Attachment 9
NRC3-12-0003
(17 pages)

Response to RAI Letter No. 70
(eRAI Tracking No. 6244)

RAI Question No. 03.07.01-7

Figure 2: Response spectral shapes (5% damping) for Fermi 3 HF and LF controlling earthquakes based on NUREG/CR-6728 CEUS rock spectral shapes.

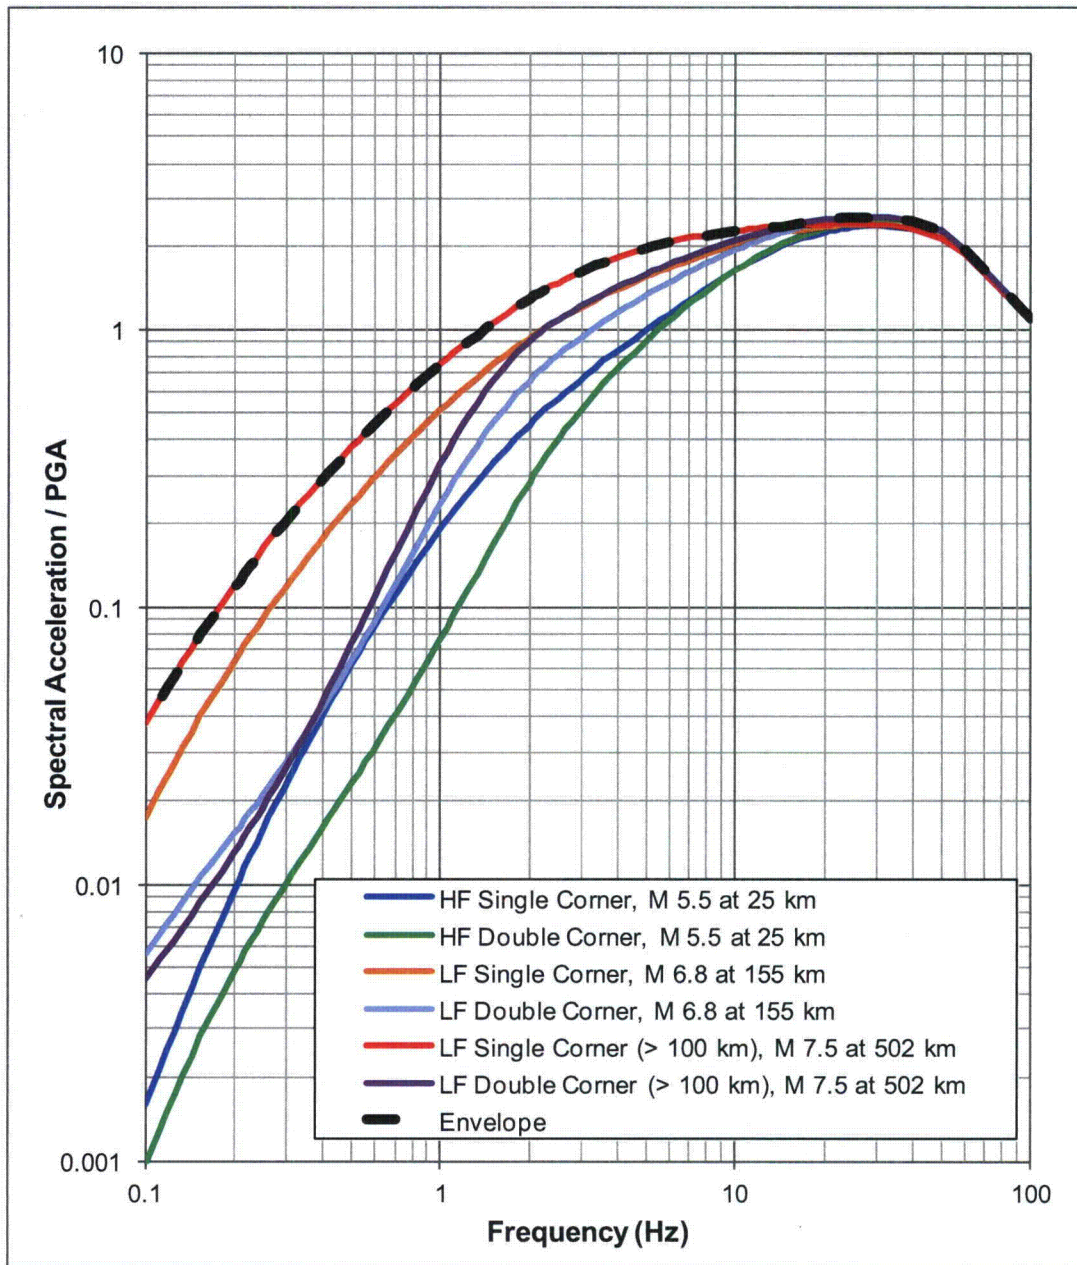
However, the guidance in SRP 3.7.1 and ISG-017 also indicates that, to satisfy the regulatory requirements, the minimum horizontal PGA of 0.1g should correspond to a smooth broad-band spectral shape such as the one described in RG 1.60. Therefore, the applicant is requested to provide in the FSAR comparison plots of the RB/FB and CB horizontal FIRS with the RG 1.60 horizontal spectrum anchored at 0.1 g, which demonstrate that the RB/FB and CB horizontal FIRS envelope the RG 1.60 spectrum at all frequencies of interest. The staff needs this information to confirm that the site-specific seismic input used in the site-specific SSI analysis meets 10 CFR Part 50, Appendix S.

Section 3.1 of NUREG/CR-6926 suggests that the CEUS spectral shapes provided in NUREG/CR-6728 (McGuire et al., 2001) are more appropriate for hard rock sites. Figure 2 shows CEUS rock site spectral shapes developed using the relationships presented in NUREG/CR-6728. These shapes are developed using the average of the 10^{-4} and 10^{-5} controlling earthquake magnitudes and log average of the controlling earthquake distances. NUREG/CR-6728 presents spectral shapes based on two alternative models for the shape of the earthquake source spectra: a single corner model and a double corner model. Figure 2 shows both of these spectral shapes. A single enveloping spectral shape is constructed, as shown by the heavy dashed line on Figure 2. Figure 1 shows that the RB/FB and CB SSI FIRS are greater than the enveloping NUREG/CR-6728 spectral shape from Figure 2 scaled to a PGA of 0.1g.
